BGA TECHNICAL COMMITTEE

TECHNICAL NEWSHEET 7/8/99

PART 1	AIRWORTHINESS MATTERS	Please consult the BG.	A 1999 Red Pages .
--------	-----------------------	------------------------	--------------------

Inspection/ Replacement of the knurled nut at the rear control stick

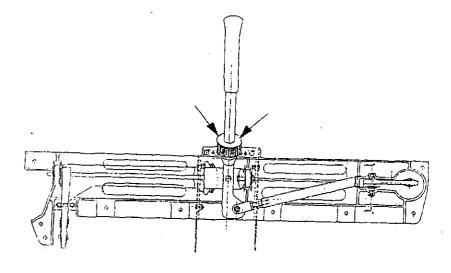
Single cases had been reported to GROB, where the fastening nut (knurled nut) was cracked. Previous investigations showed, that these damages may be caused by improper handling i.e. fastening the nut too tight. As a precautionary action an

inspection or replacement of the knurled nut is mandatory.

1. The knurled nut muts be checked for damage, especially for cracks on the lines side of the nut. If the nut is found damaged or cracked, the nut must be replaced immediately.

- 2. The inspection must be repeated before the first flight of a day, until the knurled nut is replaced.
- 3. The knurled nut at the rear control stick must be replaced for a new knurled nut made from stainless steel.
